**PERSIMMON HOMES THAMES VALLEY
LAND NORTH OF TODDINGTON LANE,
LITTLEHAMPTON**

**DRAINAGE STRATEGY, WEST OF
WETLANDS
(DISCHARGE OF CONDITION 10)**

JANUARY 2019

Project Code:	A/PHDRAIN.10
Prepared by:	SF
Approved by:	AB
Issue Date:	24th January 2019
Status:	1st Issue

Image below: Shows the locations of the permeable sub-base within the Windes model..

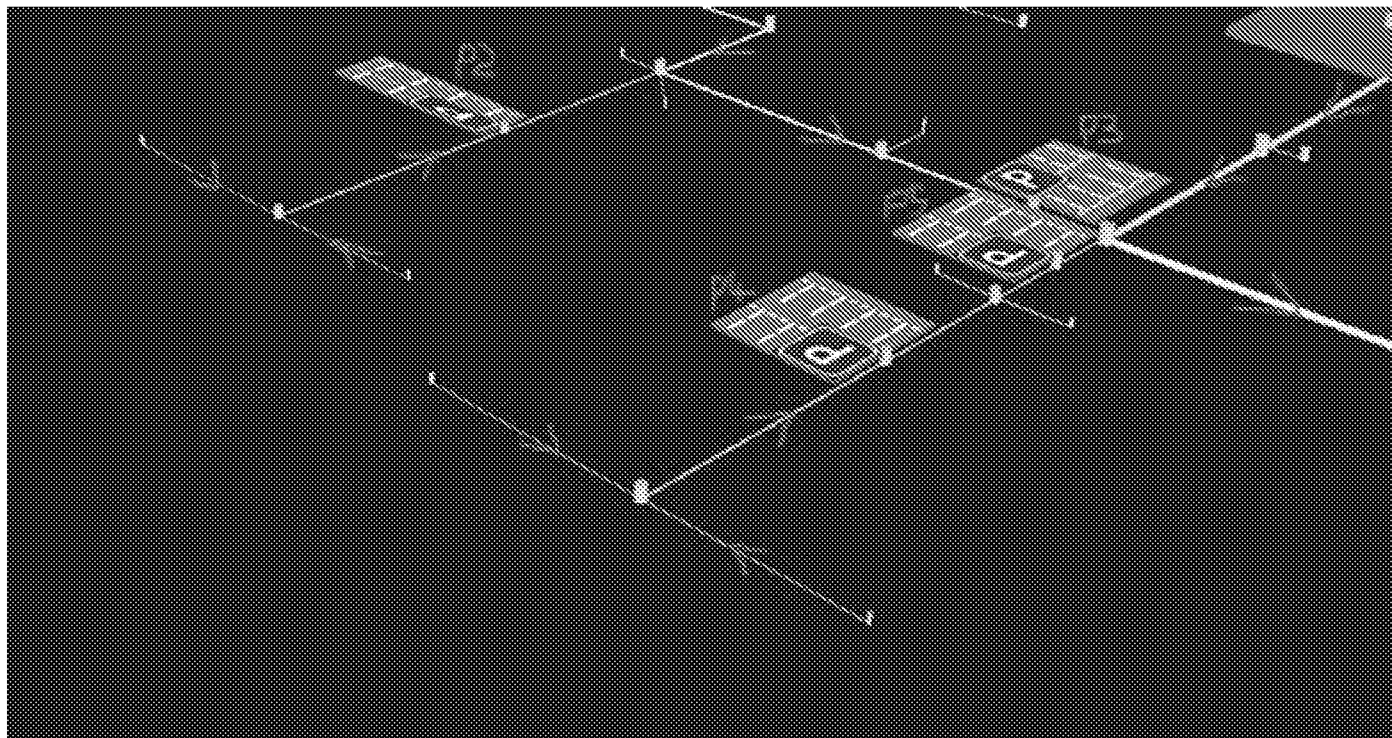
- The location of the permeable sub-base is also on the road build-up and finishes drawing. (See point 7 above) See point 3
9. Please can you model the permeable sub base roads to demonstrate if the flooded volume can be stored. Check dams etc. may need to be provided.

Whilst reading the response below please note we have updated our Windes model so it now includes the permeable sub-base. See image below where we've added new nodes and modelled it as a "porous car park" (function within the programme) where the storage within 30% voids of the granular sub-base is recognised. We have distributed it as evenly as possible across the areas where the granular sub-base is located. The addition improves the results significantly and the total flooding volume for the fully surcharged critical 1in100yr+CC storm is now only 35m3 (spread across 4 different locations) that can safely be contained within the site.

- We have added the permeable sub-base to the micro drainage model so the storage within the open graded sub-base is now included. There is no need to include check dams because the volume of the sub-base is utilised / required for the long duration. The site does slope, is subbase of all permeable subbases to be laid flat? Clarification and details of this under point 3 will be required. I will complete a full review of the calculations once point 3 is provided.
